Project	IEEE 802.16 Broadband Wireless Access Working Group < http://ieee802.org/16 >	
Title	Power Control of Uplink AAS Preamble	
Date Submitted	2005-01-27	
Source(s)	<p>Inseok Hwang, Jaehee Cho, Seungjoo Maeng, Jaeho Jeon, Soonyoung Yoon, Jeong-Heon Kim, Jaehyok Lee, Myungkwang Byun, Panyuh Joo, Jiho Jang, Sanghoon Sung, Hoon Huh, janghoon yang,</p> <p>Samsung Electronics Co. Ltd.</p> <p>Ran Yaniv, Tal Kaitz Alvarion Ltd.</p> <p>Dave Pechner, Doug Dahlby, Todd Chauvin ArrayComm Inc.</p> <p>Zion Hadad RunCom.</p>	<p>is91.hwang@samsung.com</p> <p>ran.yaniv@alvarion.com</p> <p>dpechner@arraycomm.com</p>
Re:	Recirculation of P802.16 REVe/D5a	
Abstract	Accurate spatial channel estimate is essential for AAS operation. For this end, framework for uplink AAS preamble power control is proposed.	
Purpose	Adoption of suggested changes into P802.16e/D6	
Notice	This document has been prepared to assist IEEE 802.16. It is offered as a basis for discussion and is not binding on the contributing individual(s) or organization(s). The material in this document is subject to change in form and content after further study. The contributor(s) reserve(s) the right to add, amend or withdraw material co

Fig. 2. Beam-forming Gain under Spatial Channel Estimation Error

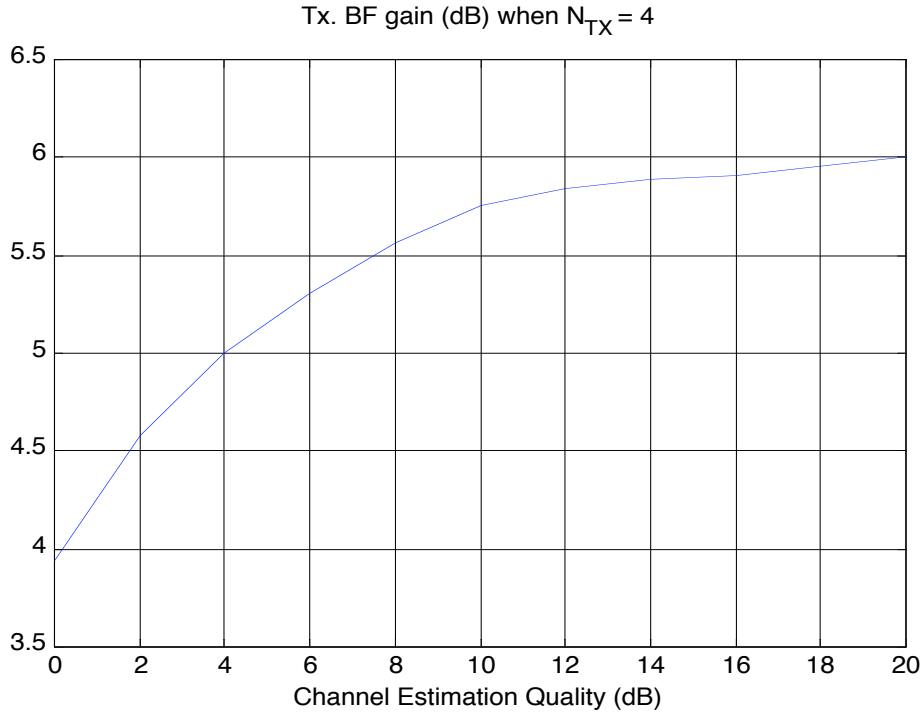
From the Fig. 2, we can find out that at least 15 dB channel estimation quality is required to achieve 0.1 dB loss. This means that SNR of AAS preamble should be greater than 9 dB for PUSC permutation since the maximum achievable filtering gain with one symbol preamble is $10 \cdot \log_{10}(4) \approx 6$ dB. The SNR of 9 dB may not be guaranteed since the transmit power for data symbol is decreased by AAS gain through the existing power control mechanism. Although the AAS gain can be used to increased modulation/FEC rate, there happens to be a case when this is prohibited for network level interference control. The object of the contribution is to provide a flexible mechanism to maintain the SNR of AAS preamble.
